**Consumers
Power
Company**

February 20, 1975

Re: Docket 50-255
License DPR-20
Palisades Plant

RESPONSES TO USNRC
Request of February 4, 1975
for Additional Information

9.0

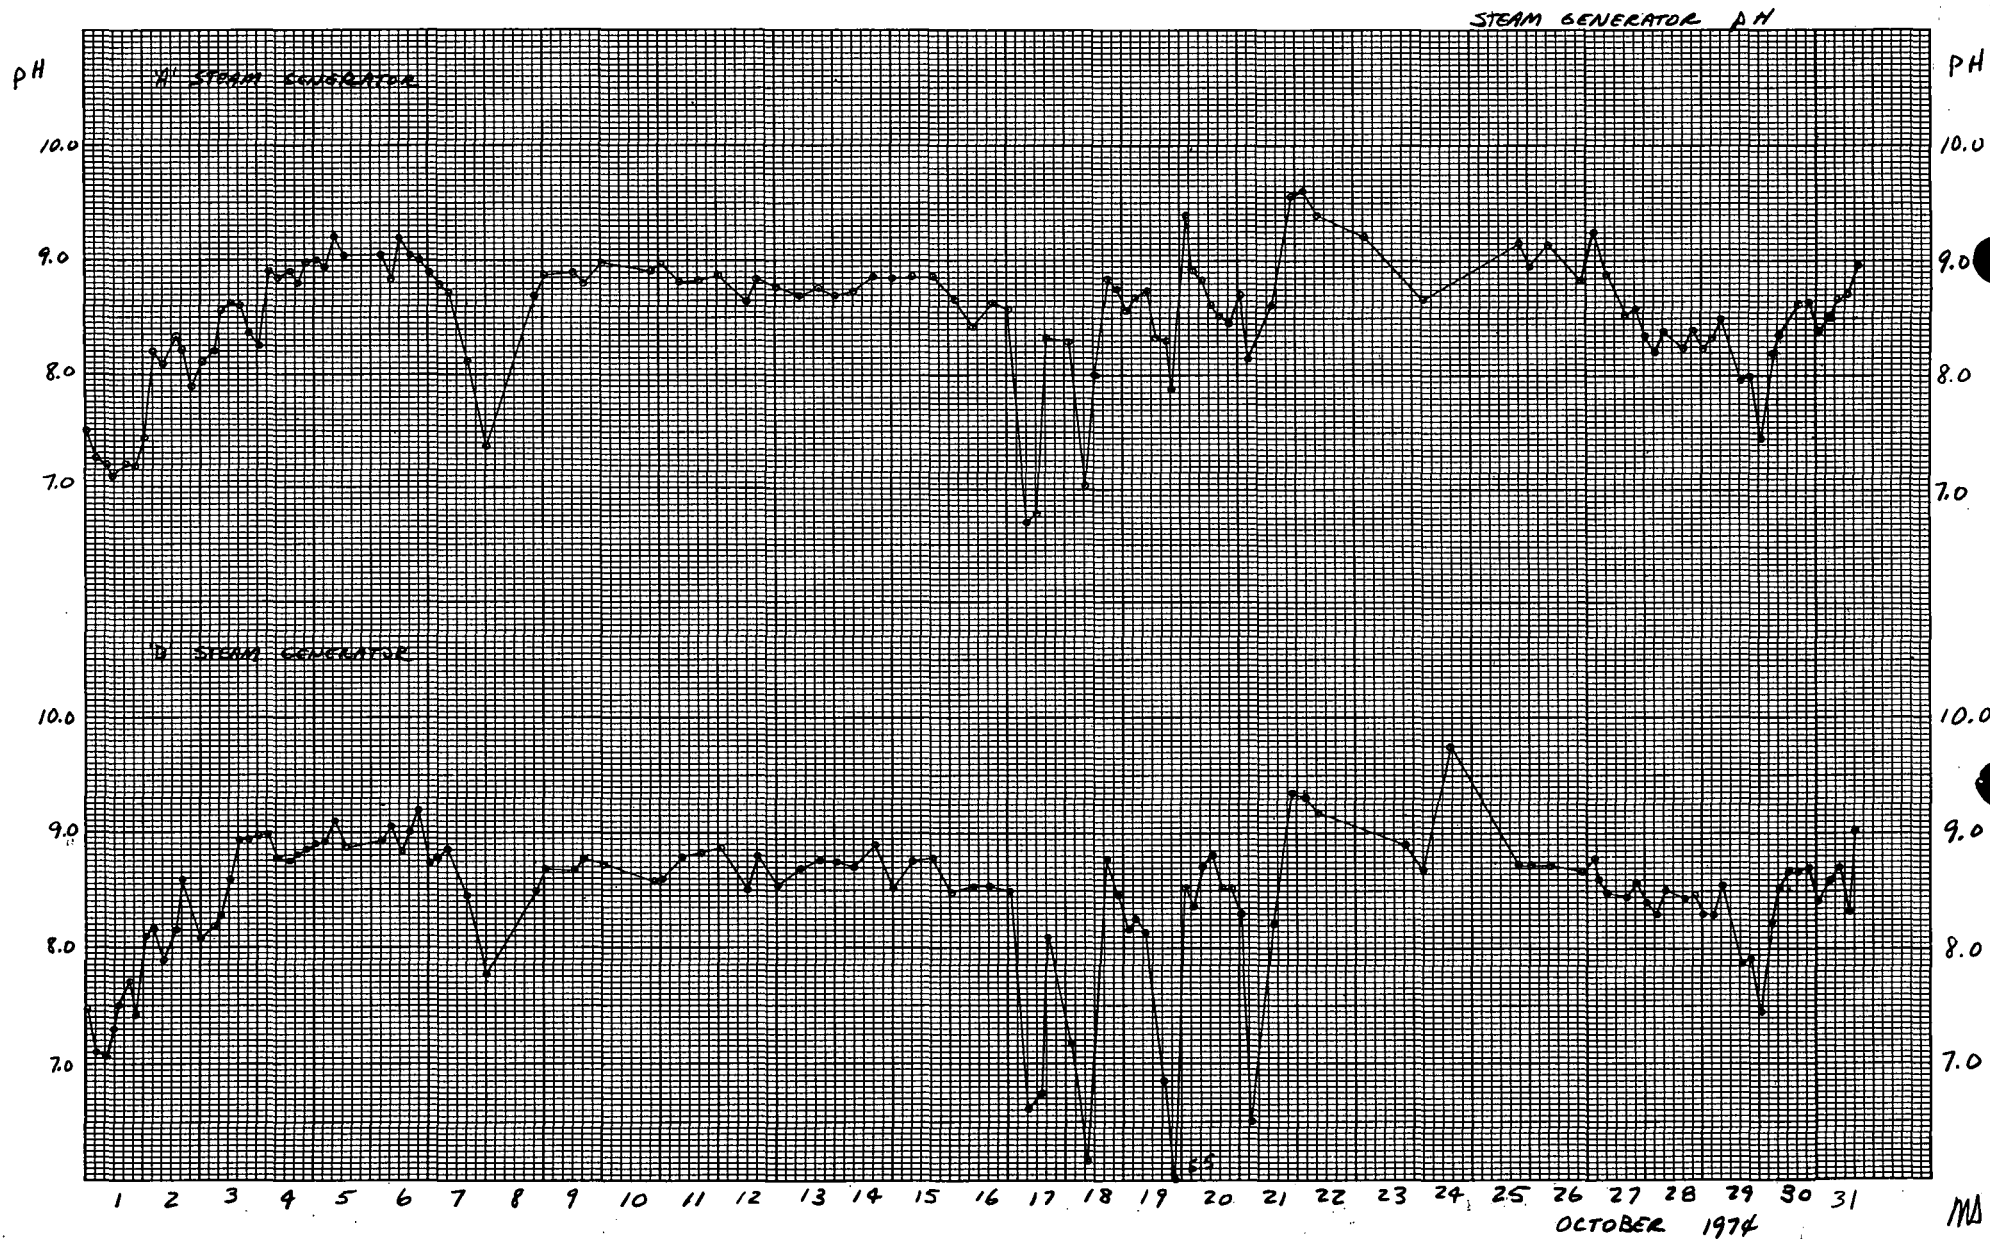
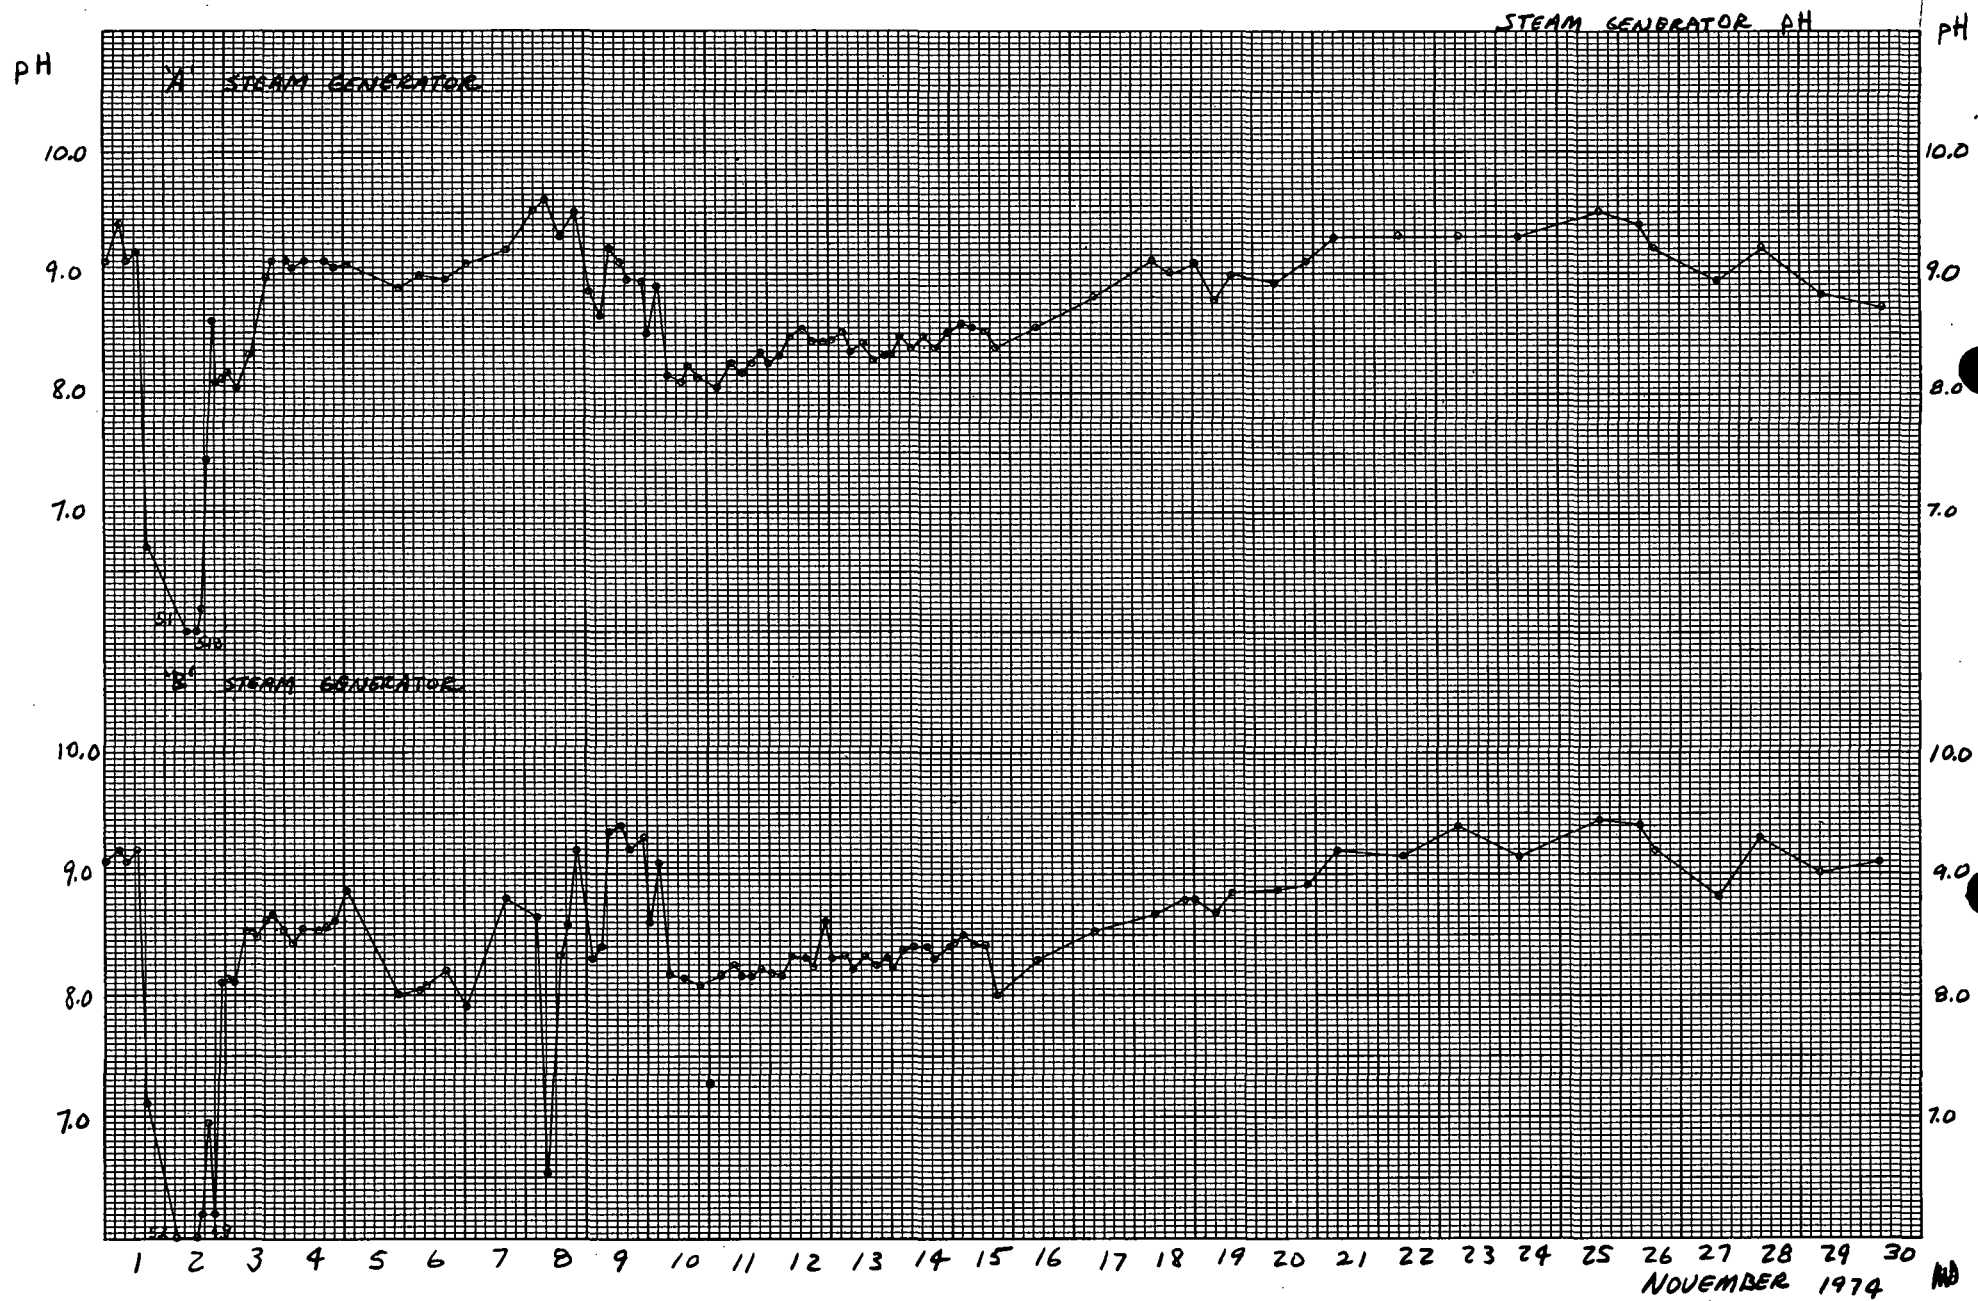
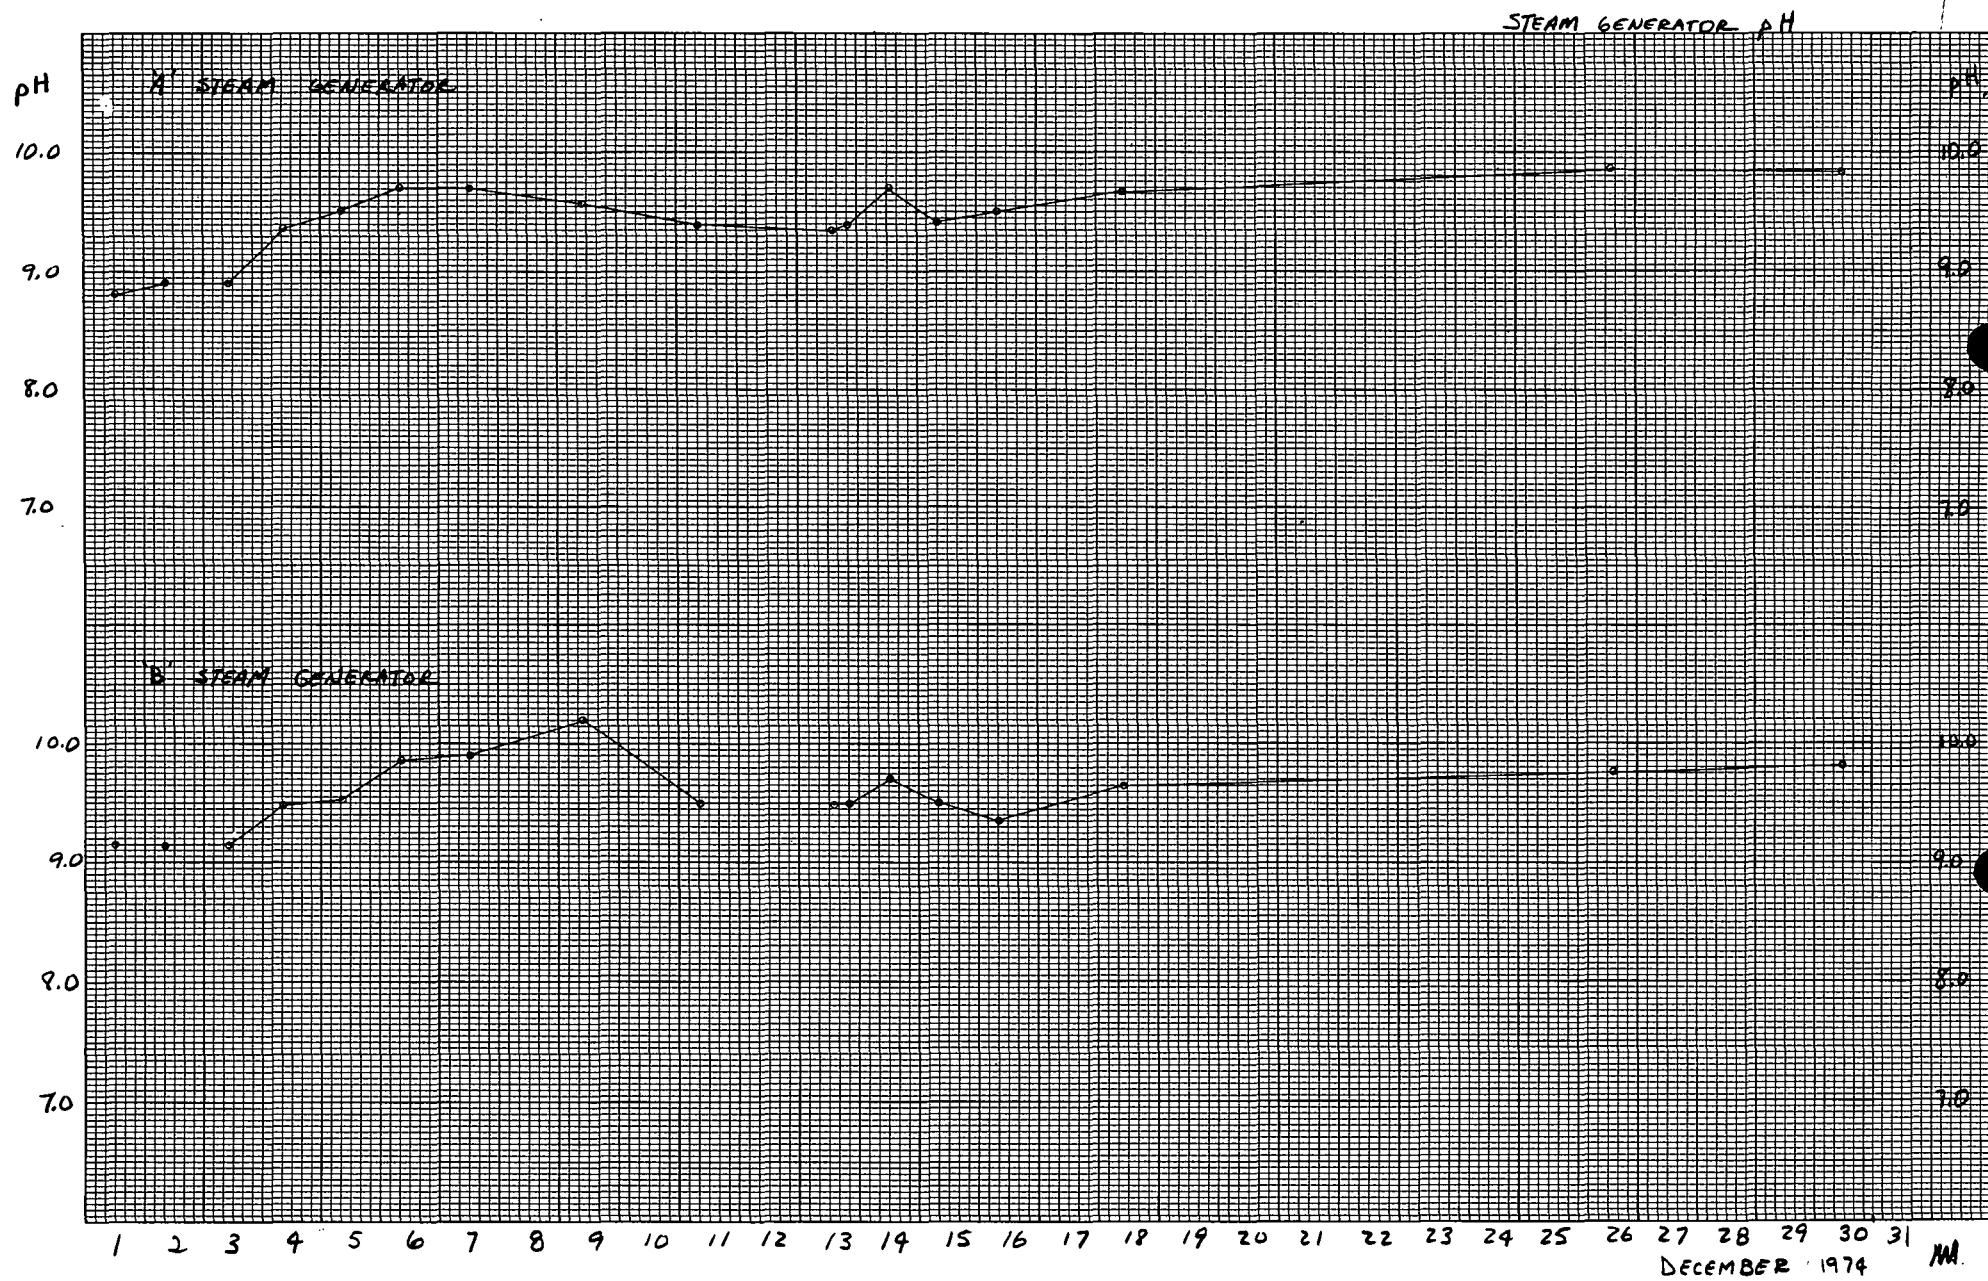
Question 6

"Provide a graph or plot showing the following as a function of time for both steam generators from the onset of isothermal flushing operations to the present:

- a. Phosphate and sulfate concentration,
- b. pH and,
- c. pounds of phosphate and sulfate removed.

The attached graphs, supplemented by the notes listed below, are provided in response to this request.

Notes

1. The letter "D" on several of the graphs indicates a sample (generally a composite) taken during a generator drain.

2. The first accounting of total PO_4 and SO_4 removed from the generators took place in early September; however, due to the error noted late in September with the PO_4 analysis, the total PO_4 removed starts in October. Quite a lot of work would be required to go back and add up the results for the missing four data points (September) and, therefore, it was not done.

3. Due to circulating water leakage (high in SO_4) after October 1, 1974, the pounds of sulfate removed from the generators were no longer calculated. It would be impossible to determine whether we are removing sulfate from the "old sludge" or from the "new sludge" caused by condenser leakage.
